Subject: 35 South Hill Park NW3 2ST.

Subject: 35 South Hill Park Nw3 2ST

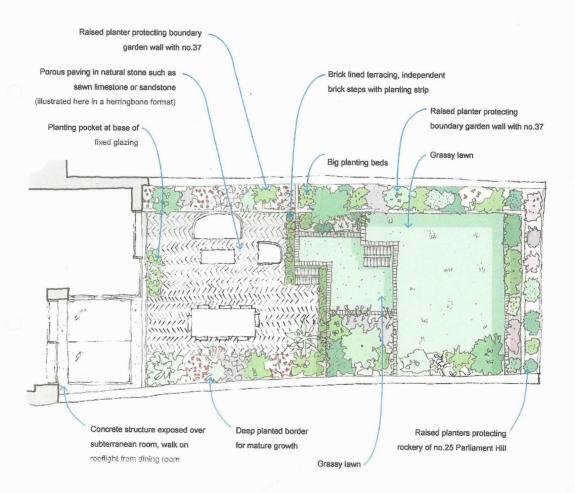
Could I please comment on the drawing 570 3D axo showing rel with 37, which came to you on the 18/03/2019. I have coloured all the glass black to be consistent and this clearly shows how dreadfully conspicuous this conservatory is prejudicing the character of the conservation area and polluting the night.

When looking at supporting document drawing No.570 3D axo showing relative position of No 35 SHP with 37SHP it can be clearly seen as an ugly protrusion into the rear garden. The permitted extension had a lower flat roof covered in sedum planting and was far less obtrusive. The conservatory on this site which previously existed as shown in attachment 1, was far less conspicuous, smaller in size, with not so much glass. All the sedum planting has now been removed.

Attached is drawing no. 570 30 axo. The other drawing 570 100319 "boundary planter" which also came to you on the 18/3/2019 is inadequate as it acts as a retaining wall for the old garden wall behind. It should have proper foundations, reinforcement and the planter should be wider as shown in the attached landscaping plan presented to committee by the developers for approval on 19/2/2015. No details of its location is given. Landscaping details as mentioned in condition 4 should also be provided and approved.
